Part 3 Responsiveness Summary

Record of Decision

Lower Duwamish Waterway

November 2014

Figure RS-1. Total PCB Concentrations (µg/kg ww, or ppb) in Fish from Puget Sound Compared to Other Common Food Sources

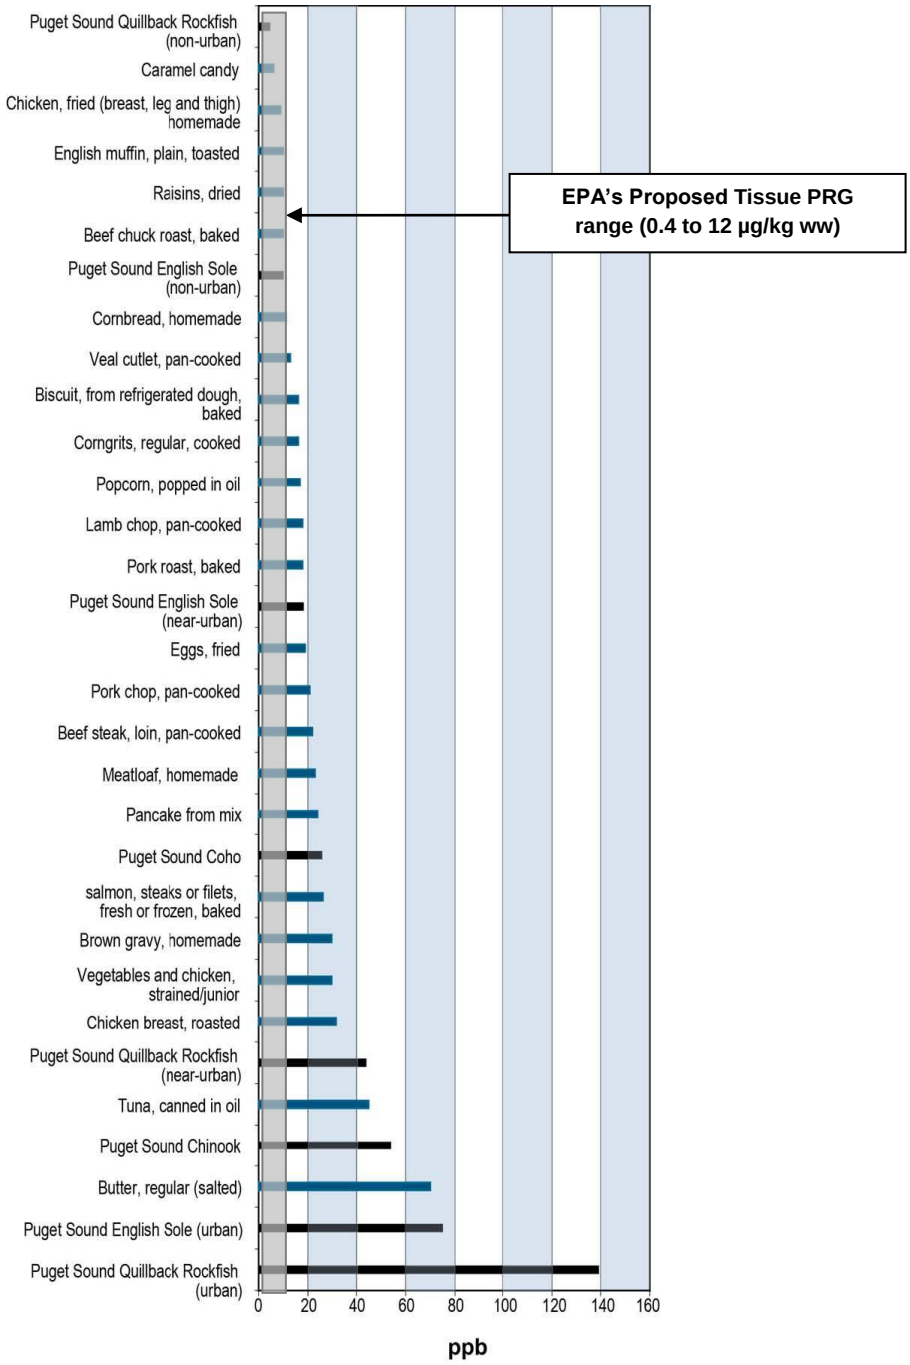
LDWG commented that: "As demonstrated in the Feasibility Study, models predict that the sediment actions will not achieve the tissue PRGs that EPA has selected for most resident fish and shellfish species regardless of the assumptions used for future sediment and water column concentrations. To place this in context, many common food sources contain PCB concentrations well above the tissue PRGs for PCBs because PCBs are ubiquitous in the environment. Selecting unachievable PRGs is inconsistent with CERCLA guidance, sets false expectations concerning what the remedy can achieve, and results in an ambiguous compliance standard. Further, because tissue cleanup levels would be established only under CERCLA, and would therefore not be ARARs, they could not be waived by EPA no matter how unachievable they are. This leaves both implementing PRPs and EPA with the task of achieving the impossible. This approach is not required, is misleading to the public, and will only cause confusion and difficulty for both EPA and PRPs, while adding no value to the cleanup itself." LDWG included Figure RS-1 to illustrate their point.

A local business commented: "It is inappropriate to establish preliminary remediation goals (PRGs) for fish tissue. The Proposed Plan states that the in-water remediation will focus on reducing concentrations of contaminants in sediment, not surface water or fish. Fish tissue contamination can often times be related to sediments outside the study area, or to exposure to other media/releases both inside and outside the study area (e.g., surface water, stormwater, air-deposition, and overwater activities). Although long-term monitoring of fish tissue can provide important information regarding the overall health of a river system, it is not a reliable or reasonable gauge for remedy performance. In addition, [Proposed Plan] Section 7.2 states: *'Table 10 lists PRGs for resident fish and shellfish (crab and clam) tissue for RAO 1. Tissue PRGs are based on the higher of: the RBTC at 1 in 1,000,000 excess cancer risk or HQ of 1 for the adult Tribal RME scenario; or the current concentrations in non-urban Puget Sound data. Fish and crab tissue PRGs must be met as a 95% UCL LDW-wide. Clam tissue PRGs must be met as a 95% UCL across all clamming areas.*' This statement is troubling for several reasons: a) it is inappropriate to utilize non-urban Puget Sound data to establish background for the LDR [sic –LDW was meant] since the Puget Sound data set includes numerous locations that are quite different from the LDR (e.g., in terms of the physical, chemical and biological aspects), and b) there is no supporting rationale for requiring the cleanup to meet 95% UCL of the PRGs."

Figure RS-2. Depth distribution of infaunal bivalves (Kondo 1987)

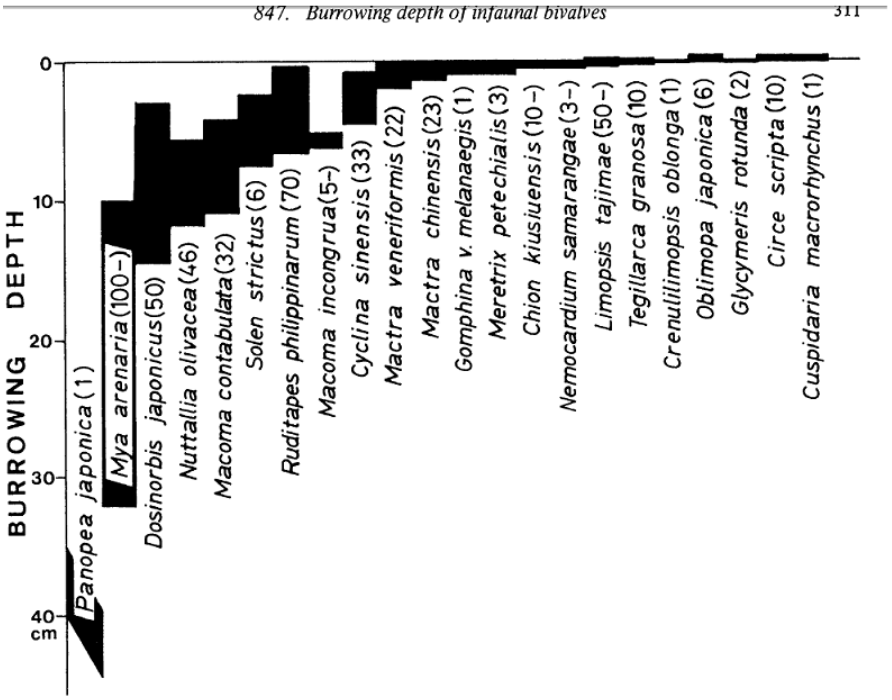
A local business commented that the Proposed Plan is inconsistent in the remedial approach to be employed at clamming areas because it states that PRGs in clamming areas must be met in the upper 45 cm, but later says that caps in clamming areas must be no less than four feet in depth or 122 cm. These standards appear to conflict. If the PRGs apply only to the upper 45 cm, then why would a cap need to be nearly three times as deep?

The eastern softshell clam (*Mya arenaria*) has burrowing depths in the range of 25 to 35 cm (Figure RS-2). However, a clammer would not stop at the upper end of the shell, but would rather need to dig around the clam to extract it. The Oregon Department of Fish and Wildlife recommendations for excavating soft shell clams (ODFW no date) emphasize the fragility of soft shell clam shells and siphons and suggest excavating around the margins of a location where a clam might be expected to be. The size of a mature eastern softshell clam ranges from 5 cm up to 15 cm. Thus, consideration of the size of the clam to be excavated and depth would result in an excavation depth of 40 to 50 cm. Providing for a best professional judgment excavation margin of approximately 5 inches to avoid damaging clams would also be appropriate. Given the considerations of clam depth, clam size, and the need to excavate around clams, a depth of 45 cm is readily justified.

Figure RS-3. Feasibility Study Figure ES-11

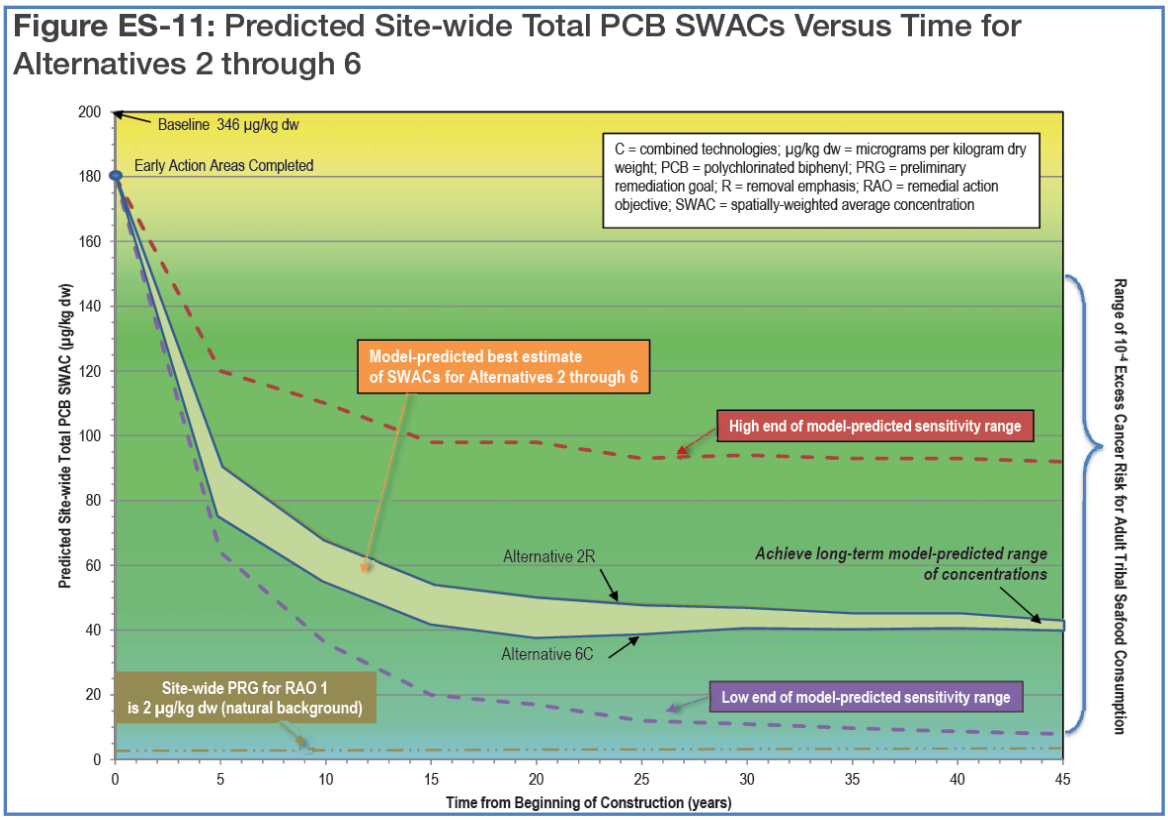
Some commenters, including LDWG members, businesses, and consultants asked that the ROD clarify the cleanup results within the context of local, regional, and international exposures to contaminants from various sources, including seafood consumption. For instance, they note that both adjacent Elliott Bay and Lake Washington have fish consumption advisories in place and remain above the MTCA levels of acceptability. FS evaluations using the Bed Composition Model (BCM) showed that none of the action alternatives were projected to result in levels suitable for unrestricted use of the LDW for resident fish consumption, that the desired results (PRGs) are not achievable in the waterway, and that predictive modeling in the FS indicates that the long-term reduction in carcinogenic and non-carcinogenic risks will be similar for all Alternatives, 2 through 6, at variable times between 10 and 45 years following beginning of construction. All of the alternatives would be expected to reach a long-term model-predicted concentration within 17 to 25 years of beginning construction, with the exception of Alternative 6R, which would take 42 years. They stated that the Preferred Alternative (which has a construction time of 7 years and relies more on dredging, capping, and ENR) is predicted to achieve cleanup objectives in 17 years, whereas Alternative 3C (which is constructed in 3 years, and relies more on MNR) is predicted to achieve cleanup objectives in 18 years. One comment requested that Figure ES-11 of the FS be included in the ROD to illustrate this (the figure is reproduced below as Figure RS-3).

Commenters stated that over time in the LDW, incoming sediment concentrations will dominate the biologically active zone (BAZ) and become the primary determinant of site risks. As noted in the Proposed Plan, the BCM predicts that, at the "best guess inputs," the long-term surface spatially-weighted average concentrations (SWAC) for all remedial alternatives converge to a similar value, or steady state. The other bounds (high end and low end) are applications of the BCM to determine how sensitive the outcomes are to a set of higher and lower bound upstream and lateral load inputs.

Figure RS-4. Figure 10-6 from the FS with the results of the UCL95 cases shown in Table RS-1

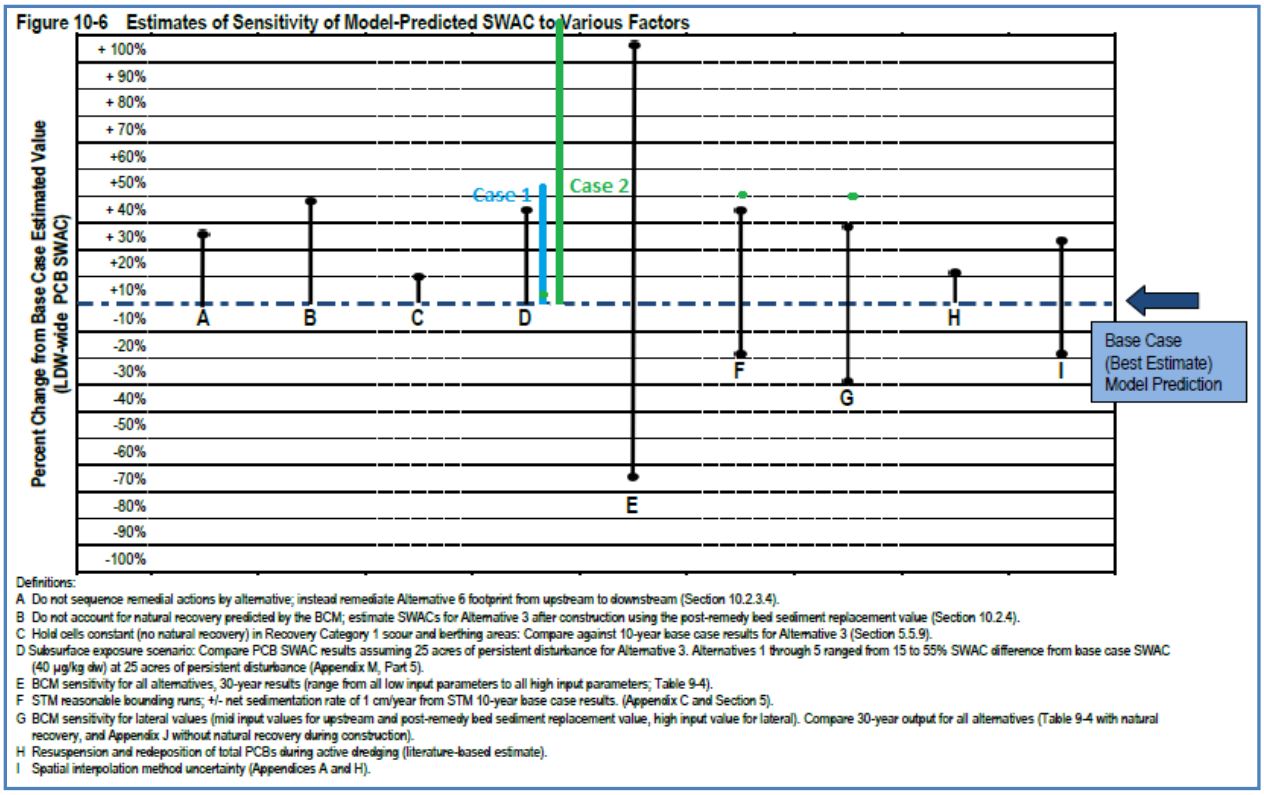
Commenters suggest that model sensitivity runs varying assumptions other than those for Green/Duwamish inputs (model run E in Figure RS-4) showed a narrow range of outputs. However, not all sensitivity runs were testing independent events; for example, both low natural recovery (in model runs B and C) and subsurface-to-surface recontamination (in model run D) could jointly increase steady-state concentrations in the waterway, leading to higher uncertainty than shown in the FS analysis. In addition, the analysis conducted in the FS and illustrated in Figure RS-4 fails to account for releases of contamination to the water column which may occur as a result of a disturbance of subsurface contaminated sediments and consequent impacts to COC concentrations in benthic invertebrates, fish, and wildlife. This sediment-only view potentially understates impacts of a release of subsurface contamination due to ship scour or other disturbance events on future fish and shellfish tissue concentrations.

LDWG's interpretation of the analysis in Appendix M, Part 5 of the FS (model run D in Figure RS-4) did not fully address potential for releases of subsurface contamination. EPA evaluated the LDWG analysis in light of the Selected Remedy's compliance framework (see ROD Section 8), using the UCL95 as a compliance statistic instead of the SWAC used in FS Appendix M. EPA used a simple simulation (applying reasonable values that represent excursions above the steady state) to estimate how the UCL95, which is the compliance requirement in the ROD, would be affected. ProUCL version 4.1 software was used for the calculations. This analysis is described below and summarized in Table RS-1.

Results are shown in Figure RS-4; blue and green lines represent the results shown in Table RS-1. All other lines shown in the figure are SWAC estimates from the FS; the "0" line represents a mid-range steady-state estimated SWAC of 40 µg/kg PCB. Case 1 (blue line representing 5% of waterway) exceeds the SWAC range for 10% of the waterway subject to recontamination according to the cited Appendix. Case 2 (green line) exceeds the full range of the high-end sensitivity run. Thus, the use of SWACs in the FS tends to compress differences in subsurface-to-surface predictions for PCBs, and areas that are not performing as intended (i.e., recontaminating or incompletely recovered under MNR) could be more influential than indicated in the FS. Subsurface recontamination may thus represent a significant factor to hinder the success of waterway cleanup. In summary, the UCL95, which is used for determining compliance with cleanup levels, is more sensitive to subsurface-to-surface recontamination than the SWAC, so the analysis in the FS likely underestimates the significance of these events on long-term COC concentrations.

Figure RS-5. Green and Sustainable Remediation Metrics for Technologies

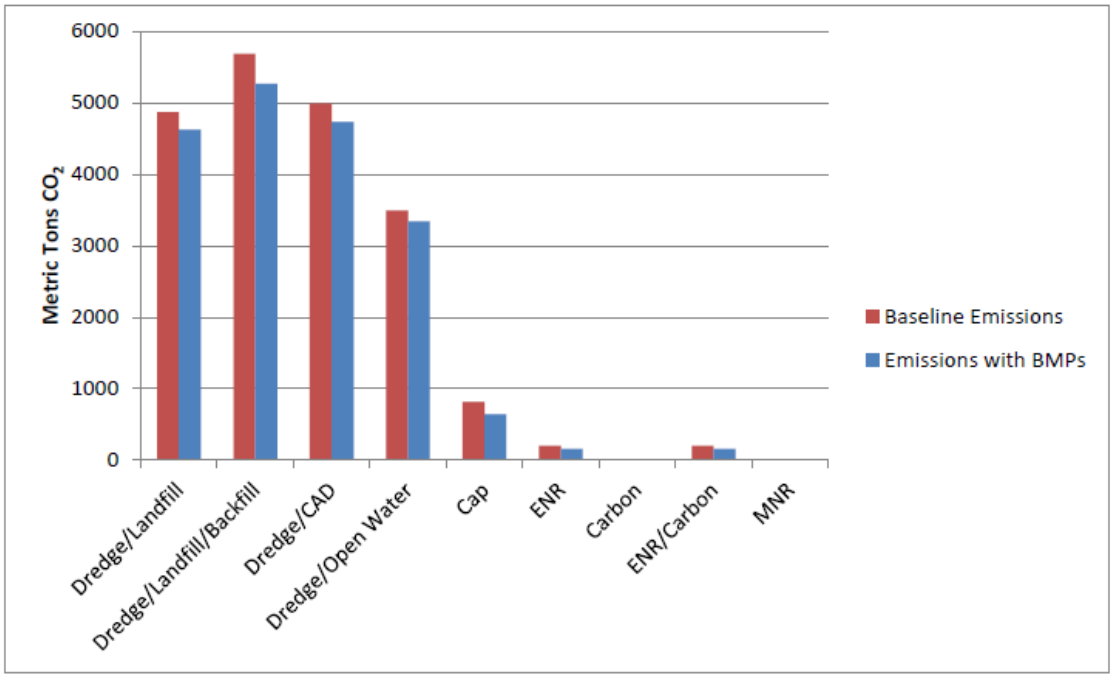
Some commenters noted that Green and Sustainable Remediation metrics are worse for longer construction periods and for alternatives with more emphasis on dredging and disposal over containment, ENR and MNR (Figure RS-5 below), and that this fact was not given adequate weight by EPA in identifying the Preferred Alternative. They stated that the Preferred Alternative's additional dredging would result in 11 metric tons of additional PM_{10} air pollutants released into the atmosphere over Alternative 3C, an increase of 73%, and that this is in a community that has higher asthma hospitalization rates than other neighborhoods in Seattle and King County.

Figure RS-6. Comparison of Adult Tribal RME Risks for LDW Remedial Alternatives

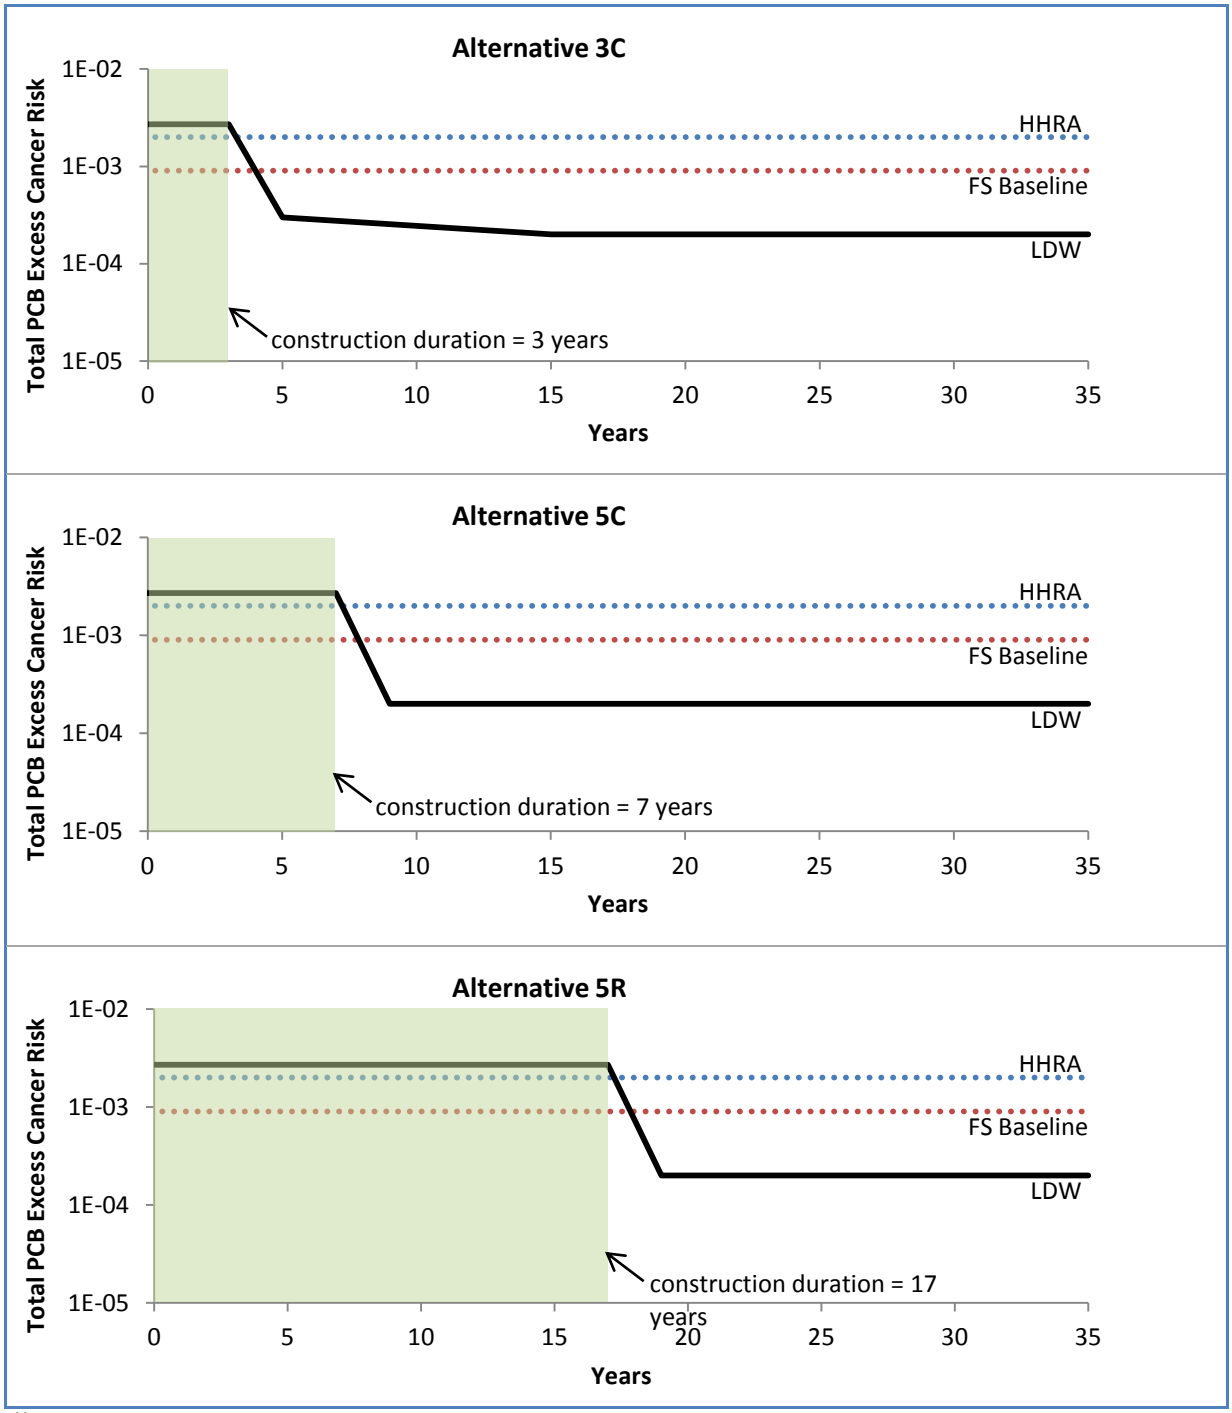
LDWG commented that EPA should have more closely evaluated the PCB releases and downstream transport during dredging activities as a metric for alternative comparison to consider changes in risks from the remedial action, rather than concluding that PCB exports generated by dredging would be insignificant compared to exports from loading upstream of the Site. Other commenters stated that this loading is the same for all alternatives, does not represent a Site release, and thus obscures the importance of minimizing releases caused by the cleanup action.

LDWG stated that as more dredging occurs, more PCBs would be released and exported into the down-current areas. The FS assumed what they believed to be a reasonable site-wide estimate based on documented projects with best management practices (BMPs) in place: 2 to 3% of dredged sediment lost downstream, regardless of the BMPs employed (FS Appendix M, Part 2). Commenters stated that although EPA considered the estimates to have a high degree of uncertainty, downstream dredging releases of PCBs during construction may increase risks for consumers of resident seafood, and this would be especially important for children. (LDWG's Attachment 1 Figure A1-2 is reproduced below as Figure RS-6; it shows Adult Tribal RME risks.)
